Recall Campaign

December 2013
FL649A
NHTSA # 13V-536

Subject: 5-Row Minotour Seat Barriers

Models Affected: Specific Thomas Built Buses Minotour SRW school buses manufactured June 19, 2013, through August 9, 2013.

Figure 2

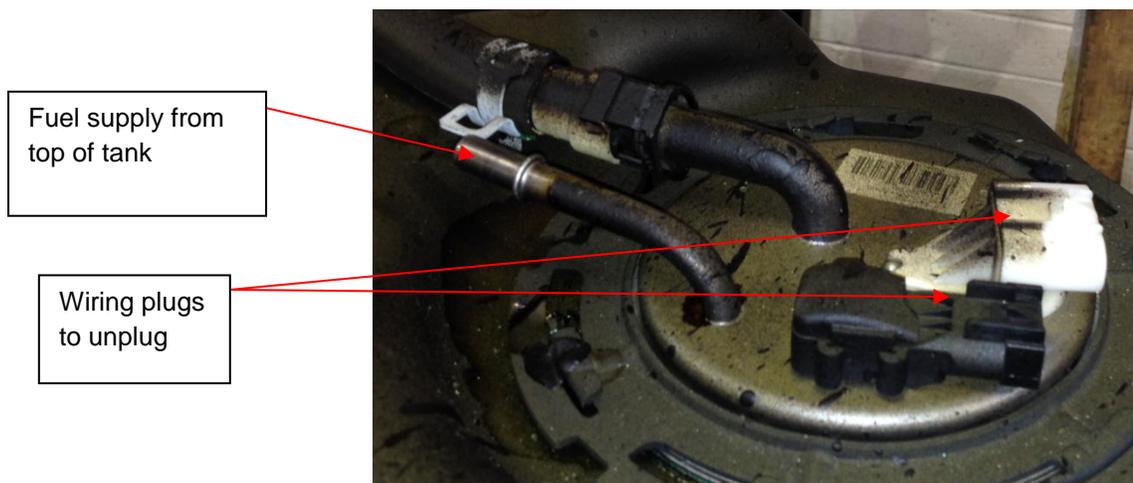
- 6) If possible, drain fuel tank to lessen weight of the tank before dropping it off the chassis.
- 7) Place cart under fuel tank to support tank after releasing it. Tank will need to be lowered enough to unplug two electrical plugs on sending unit and a fuel hose in that location, as well as the fuel hose at front of tank. (Figure 2)

- 8) Using 15mm socket, loosen two fuel tank straps from chassis.
- 9) Lower tank down several inches. Unplug two harnesses from fuel sending unit located on top of tank. **(Figure 2)**
- 10) Disconnect fuel line located beside the two plugs. **(Figure 2)**
- 11) Disconnect fuel line at front of tank near driver.
- 12) Lower the tank to cart and tape up ends of fuel connections to keep fumes from spreading. Store tank in ventilated area until reinstallation.
- 13) Weld joist reinforcement channel (TBB 183396) into location shown in **Figure 3**. (Use the measurement for joist reinforcement.) Detail shown in **Figure 4**.

Figure 6

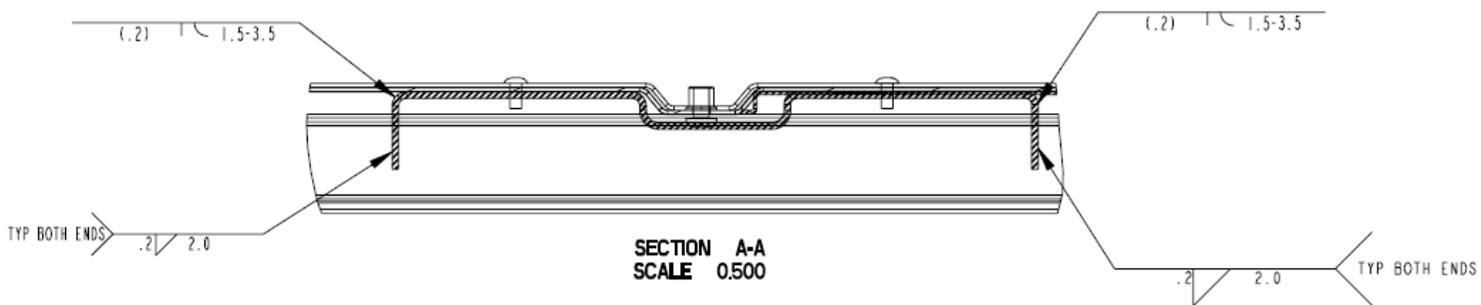
- 14) In area behind where joist reinforcement was just welded, (between it and the next joist) the nails from the installation of plywood floor must be broken off to install the floor reinforcement. This can be done by using a grinder to grind ends of nails off or using a hammer beat them flat against floor sheet. This needs to be done across to outer area of the frame rail to allow the barrier reinforcement plate to be slid over the frame rail.
- 15) To mount barrier reinforcement plate (TBB 182254), it will involve sliding the plate from the outside over the frame rail into location shown in **Figure 3**. **Figure 5** shows how to slide the plate over the frame rail. Once the plate is in place and making sure all harnesses are moved out of the way, weld plate as

shown in detail in **Figure 6**

Figure 7

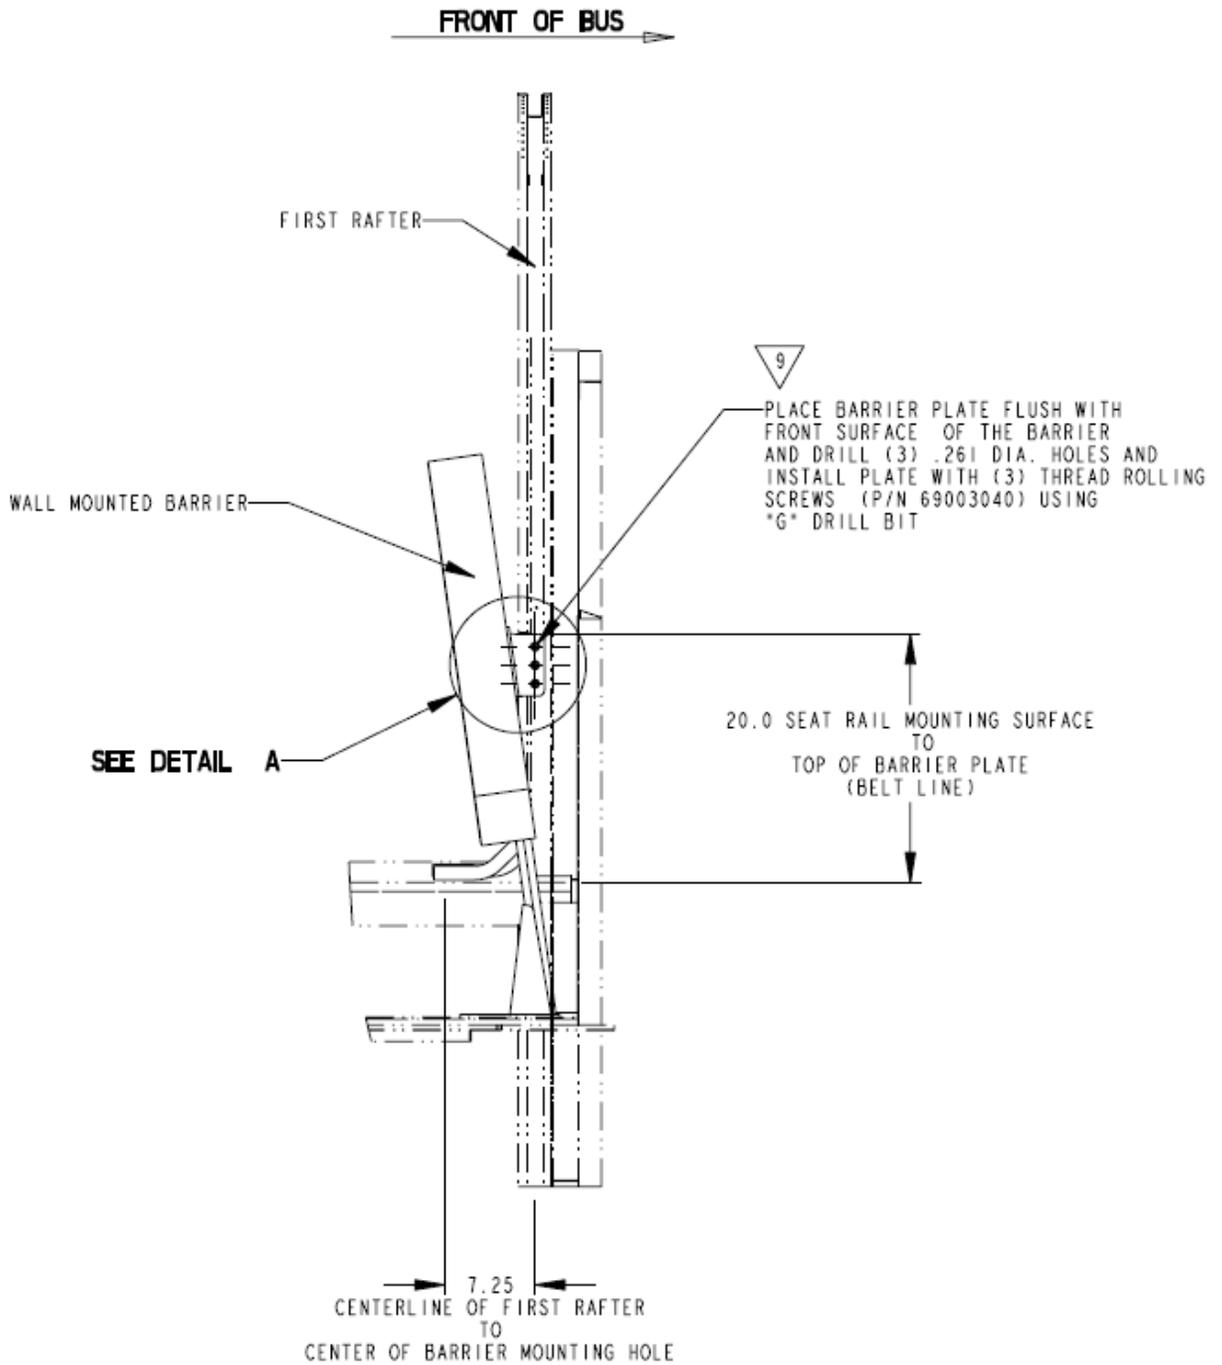
- 25) Install new pad (TBB183618) using existing screws.
- 26) Install bracket (TBB 182325) in front of barrier as shown in **Figure 7** below. This will be installed by drilling three holes using a G drill bit, and then installing with three screws (TBB 69003140). This may require loosening the barrier at seat rail in order to get bracket into correct position.
